Marina Gate 2 — Apt 2408

Snagging report · 6 Aug 2026, 09:41

Diagonal crack at window reveal

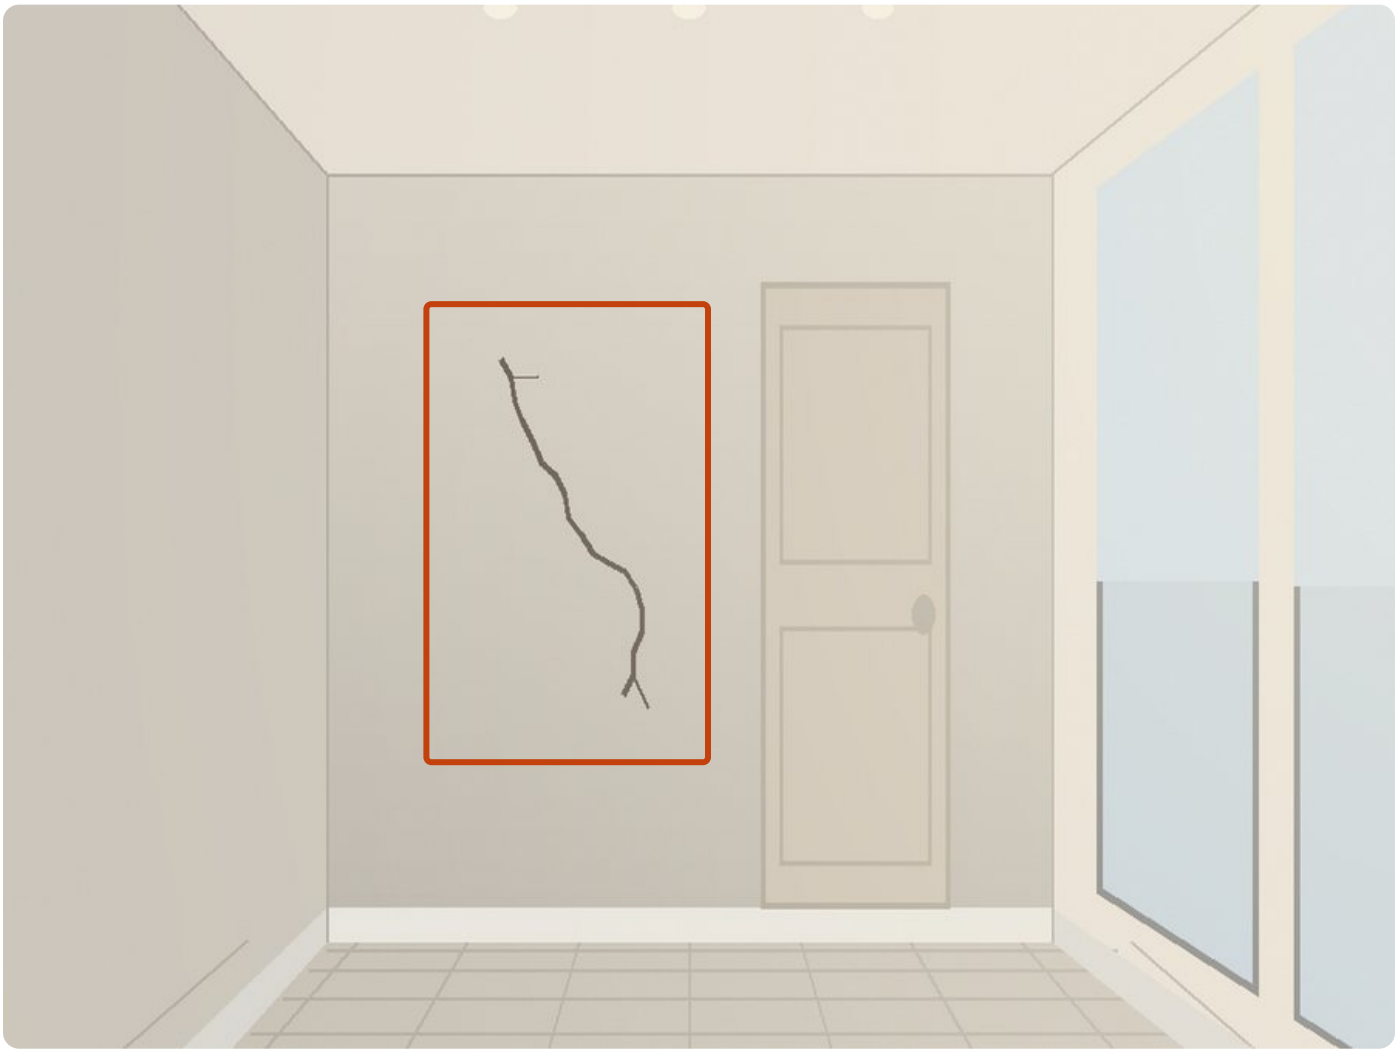
A hairline-to-2mm crack runs diagonally from the upper corner of the window reveal across the plaster. Crack is continuous rather than a paint-only hairline, suggesting movement or inadequate bead fixing.

Recommended action: Rake out, fit mesh reinforcement over the reveal corner, re-skim and re-paint the full wall to avoid a patch line.
